NH PUC Docket DE 16-442:

Petition of PSNH d/b/a Eversource Energy to Construct and Maintain
Electric Lines, Neutral Wire and Fiber Optic Cable Over/Across the
Public Lands Owned by the State of NH
in Towns of Durham and Newington

SUMMARY
Revisions between Originally Submitted Petition
And Revised Engineering Design

Changes to Original Petition

7	2
SEACOAST RELIABILITY PROJECT	
STRUCTURES #131-133	
STATE OF NH PROPERTY CROSSING	
SCALE: H 1"=200', V 1"=20'	
DATE: 07/22/16	
DES: ---	CHKD: JRS
DRW: CTS	APR: ---
TOWN: NEWINGTON	
TRANSMISSION LINE: F107	
MILE NO: ---	
DISCIPLINE/SHT NO: ---	
SHEET 1 OF 1	
F10799008

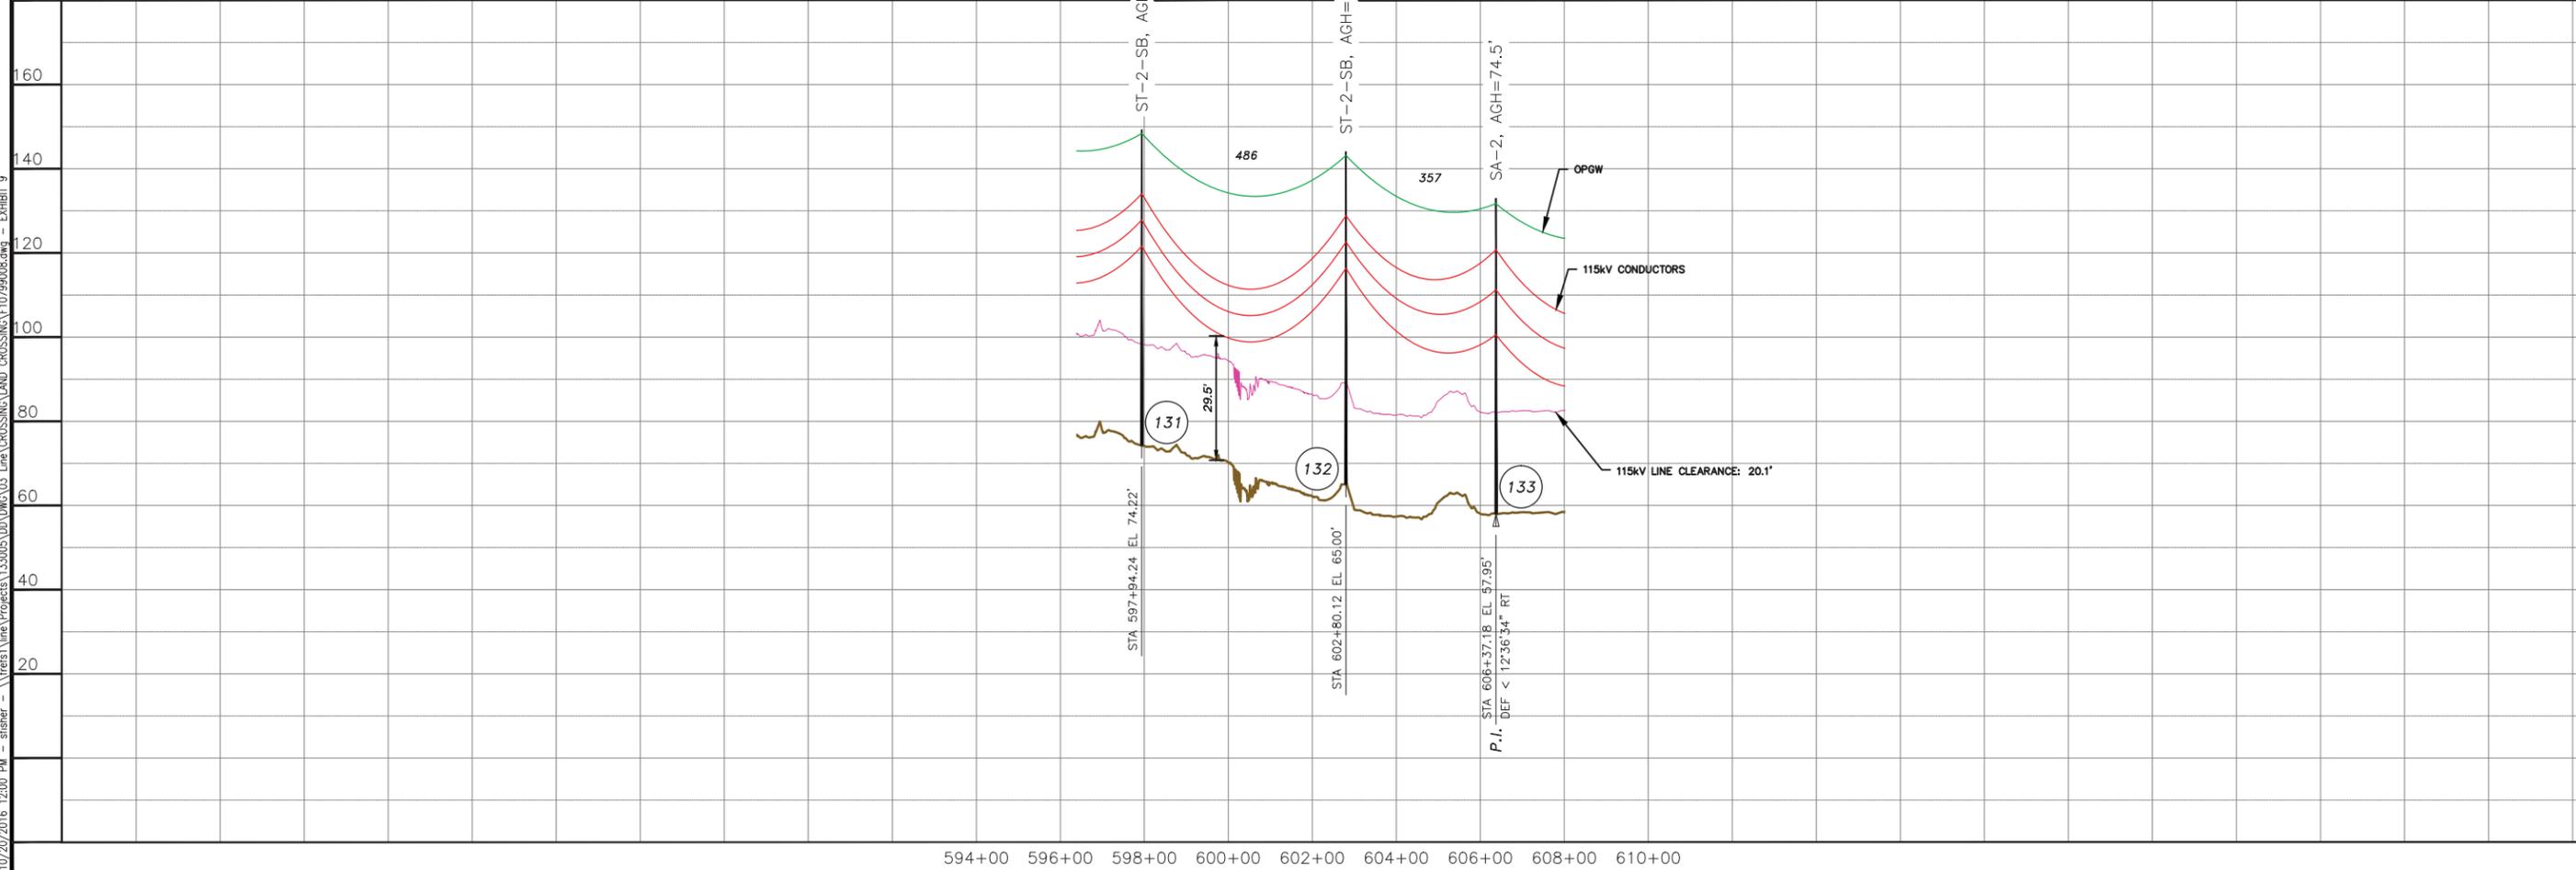
1. Paragraph #1- Revised Drawing number F10799008 (Exhibit 9) has been supplied. No changes to location plan (Exhibit 8).
2. Paragraph #3- **Change** “WT-2-UB” and “WA-2” to “ST-2-UB” and “SA-2” respectively.
3. Paragraph #3 - **Change** “7-15.5 feet” to “7-12.5 feet”
4. Paragraph #3 - **Change** “nine inches” to “six inches”
5. Paragraph #3 - **Change** “ten feet” to “10.25 feet”
6. Paragraph #5- **Change** “water” to “land”
7. **Replace** Table 3 with revised table below
